Dewberry Response to USGS Review of the Eastern Shore Virginia QL2 LiDAR BAA Project

Produced for U.S. Geological Survey

USGS Contract: G10PC00013

Task Order:G15PD00284

Figure 2- DEM_S23_4809. The above image is an overview of the DEM from the original project delivery on February 11, 2016. The below image is an overview of the DEM from the second project delivery on March 22, 2016. The cornrowing is within the <8 cm specifications.

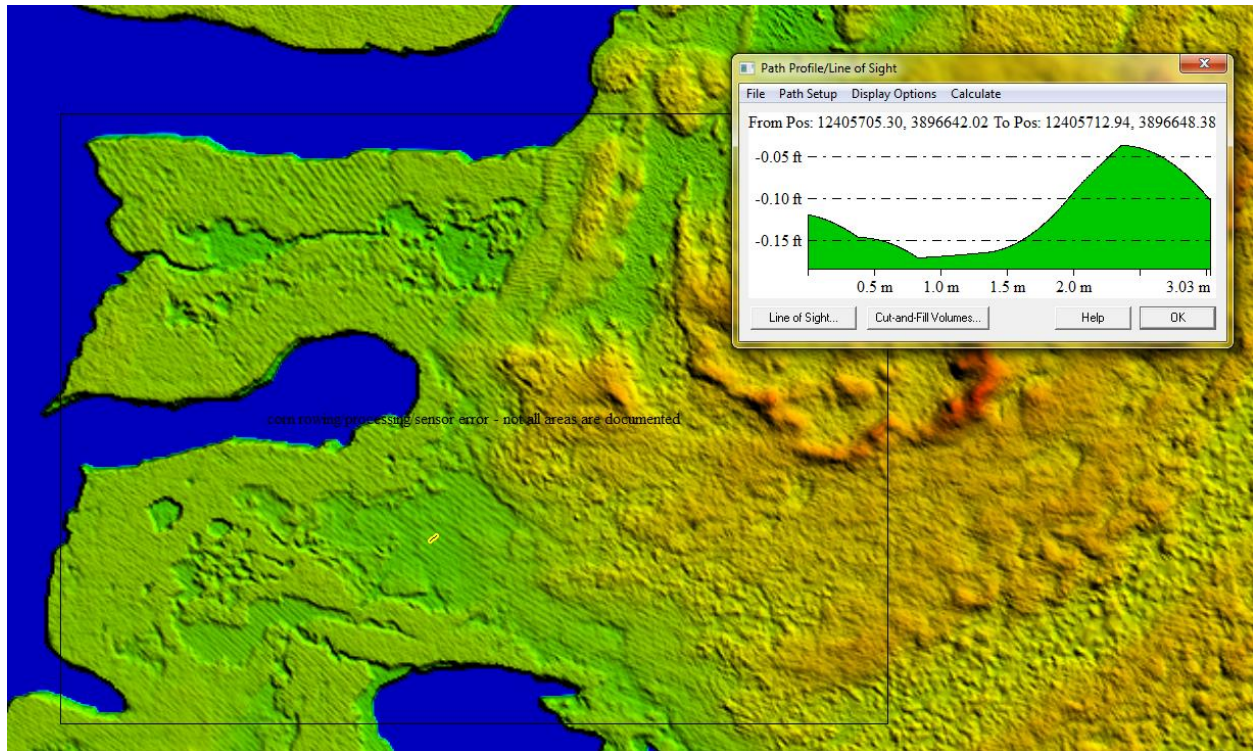
USGS made five cornrowing calls. The cornrowing was not previously called although it existed in the initial delivery. Dewberry reviewed the LAS and found that the cornrowing was within specifications (8 cm).

Figure 3- DEM_S23_3728_10 and DEM_S23_3727_20. The above image is an overview of the DEM from the original project delivery on February 11, 2016 with the floating call from USGS's first

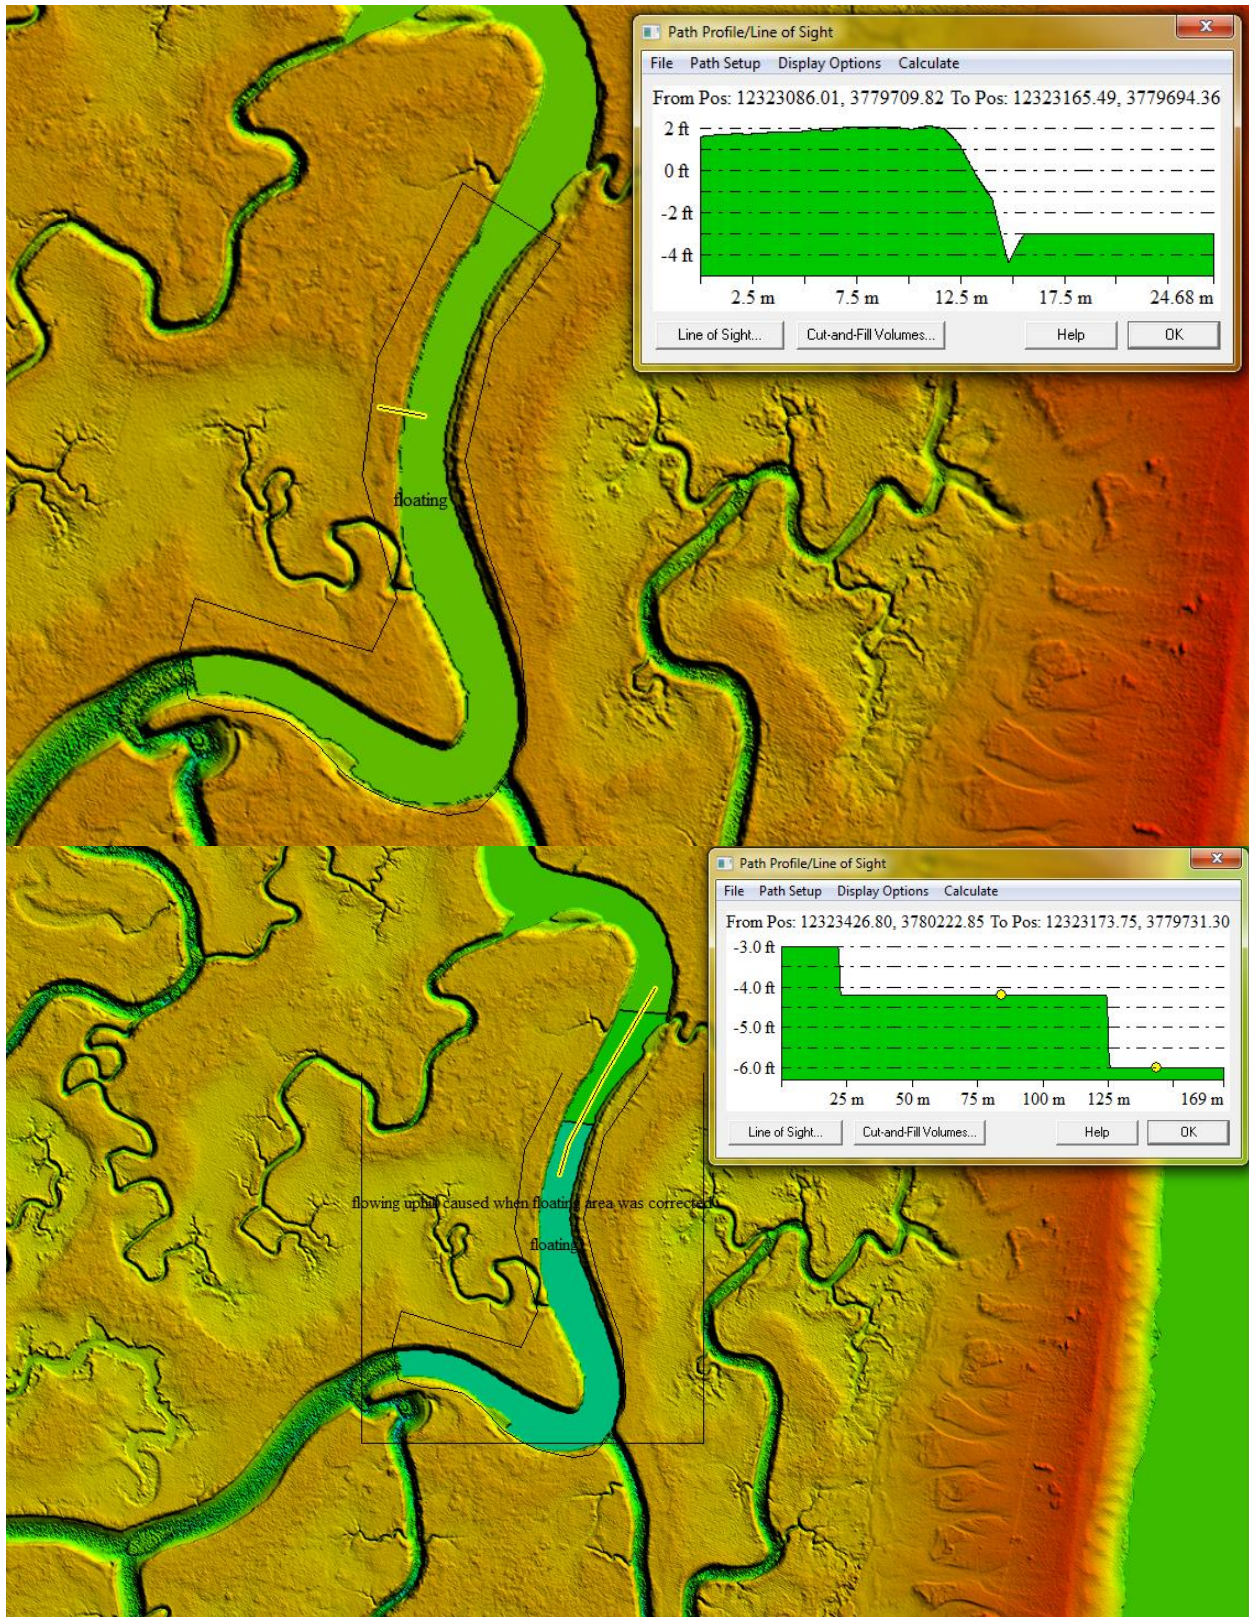
USGS made a call in a tidal area about the direction of the flow. This area was previously corrected due to a floating call on the DEM tile from the original project delivery. Dewberry corrected the area by lowering the elevation in this portion of the tidal. The tidal had to be adjusted to flow downhill to remove the floating. The USGS Lidar Base Specification v1.2 allows for vertical discontinuities within the tidal waterbodies that can be retained in the DEM. Dewberry did not deem it necessary to adjust the DEM tile.

review. The below image is an overview of the DEM from the second project delivery on March 22, 2016 with the tidal adjusted to correct the floating call.

Figure 4- DEM_S23_2754_20. The above image is an overview of the DEM where USGS made a data void call. The below image is an overview of the reprocessed DEM with the data void removed.

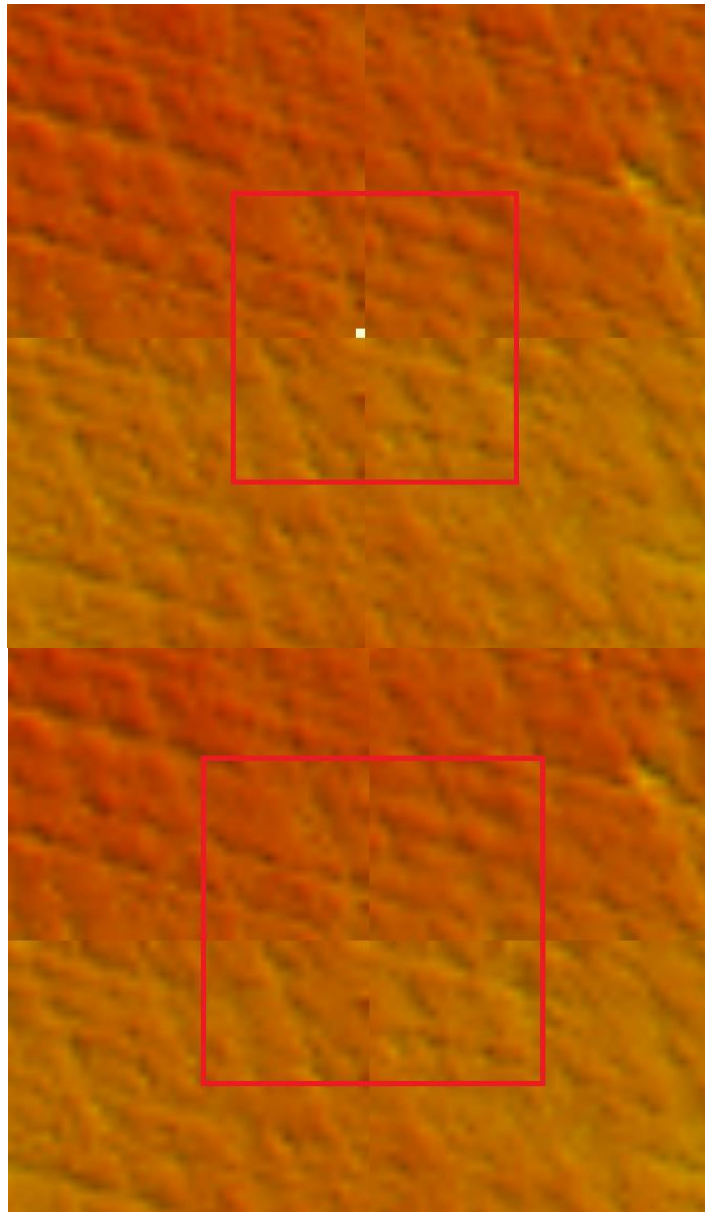
USGS made one void calls. Dewberry confirmed that the void was created during processing and has recreated the DEM tile that contained a void.

Figure 5- DEM_S23_3822_40. The above image is an overview of the DEM where USGS made a DEM call to remove a 32 foot pit. The below image is an overview of the reprocessed DEM with the pit removed.

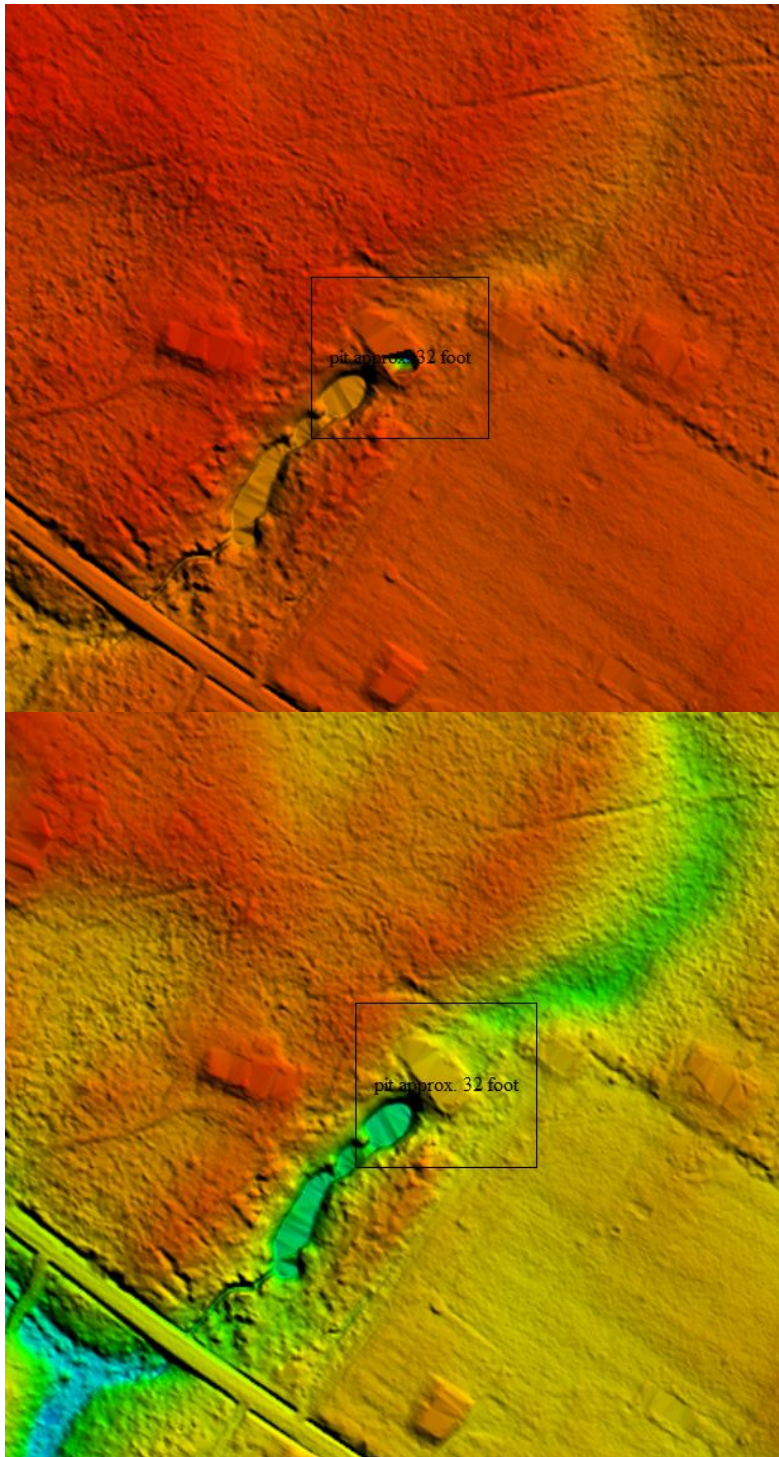
USGS made four additional DEM calls. Dewberry has corrected all the locations. An example is provided below.

Figure 6- DEM_S23_3799_30x and DEM_S23_3799_40x. The above image is an overview of the DEM where USGS made a DEM call of an elevation shift causing a seamline. The below image is an overview of the reprocessed DEM with the elevation shift minimized.

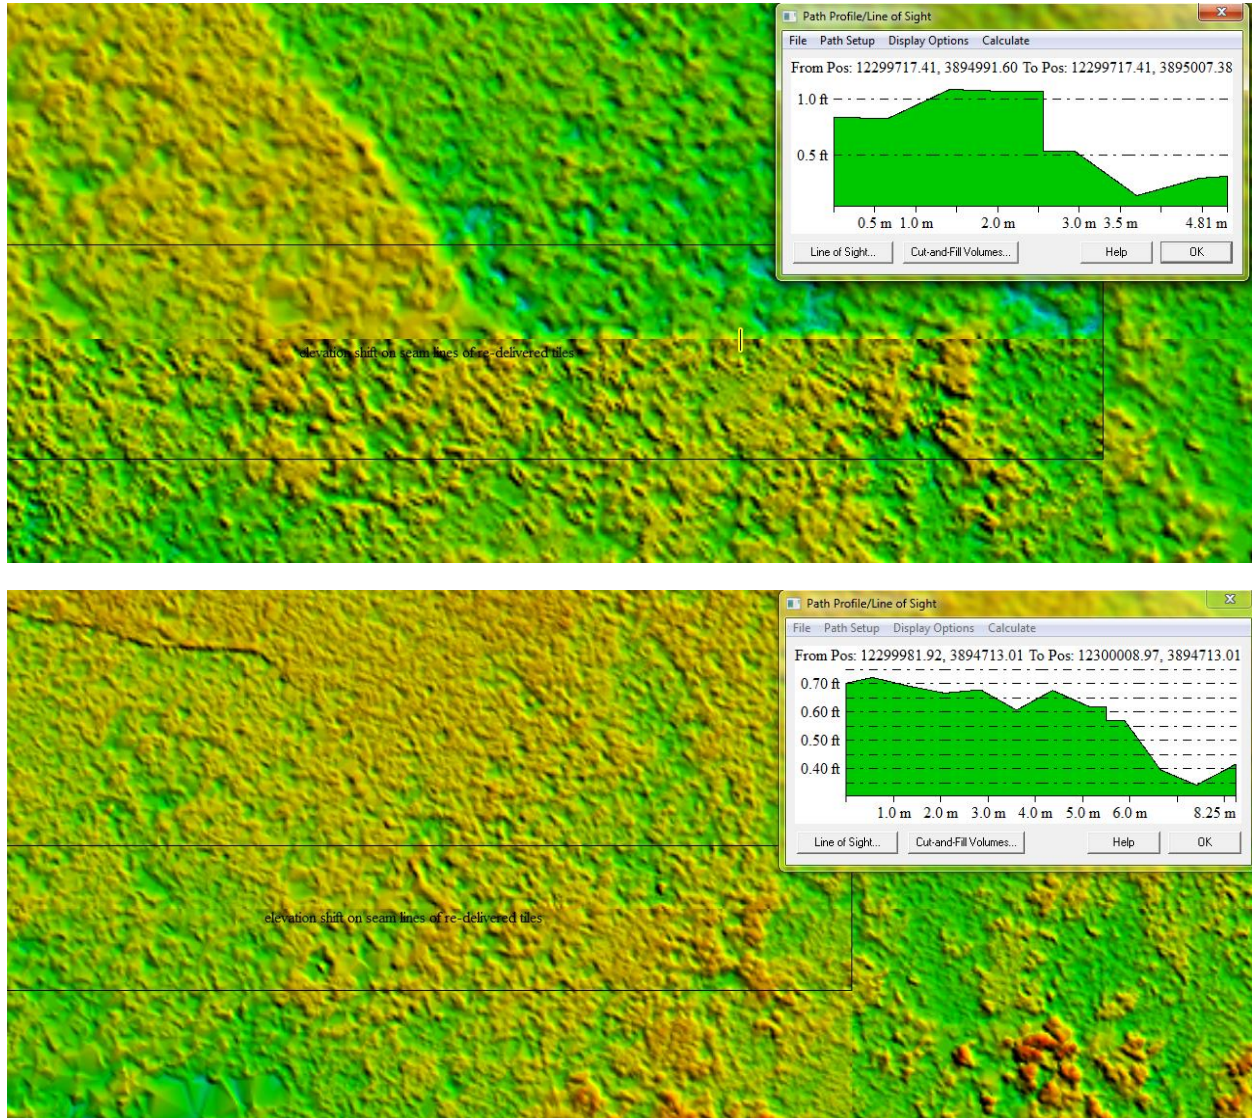
USGS made one call of an elevation shift along redelivered tiles. The elevation shift occurs on the extra tiles that are outside of the client provided boundary but within the boundary that Dewberry created. Dewberry adjusted the tile to minimize the elevation difference.
